NUMBER: 18-011-13

Flash: MIL Illumination P050B and/or Rattle/Clatter Sound on Cold Start-up

This bulletin involves installing revised heater hoses, routing the purge solenoid wire harness, and installing revised Powertrain Control Module (PCM) software.

2011 - 2013 MK

Fig. 1 Purge Solenoid Wire Harness

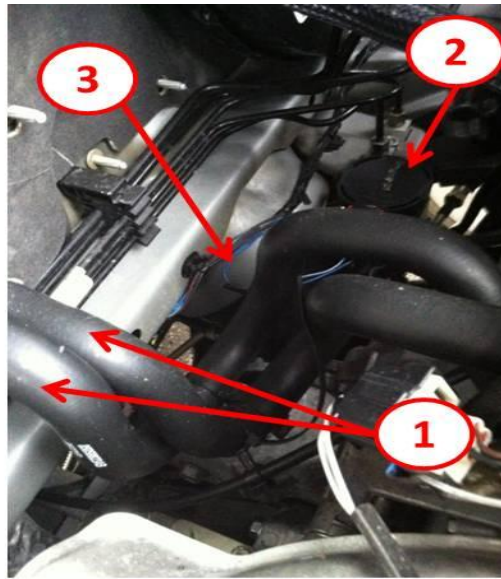
5. Without removing the pressure cap and with system not under pressure, turn draincock counterclockwise to open.
6. The coolant reserve bottle should empty first, then remove the pressure cap.
7. Allow cooling system to drain completely.
8. Remove both supply and return heater core hoses.
9. Install new heater core supply hose (p/n 05058822AB) and heater core return hose (p/n 05058823AB).
10. Install the right wheel inner splash shield.
11. Remove the engine cover.
12. To ensure that the purge solenoid wiring harness ([Fig. 1](#)) does not come in contact with the heater hoses, the wire harness will require a slight modification.

-
13. Loosely pull the purge solenoid wire harness straight and create a bend in the harness approximately 10mm (0.40 in. or 3/8 - 7/16 in.) away from the harness retaining clip edge. This bend will also create a natural bend after the current spot tape on the harness. Then, apply 3 - 4 wraps of electrical tape securing the bend to the harness as shown in ([Fig. 2](#)).
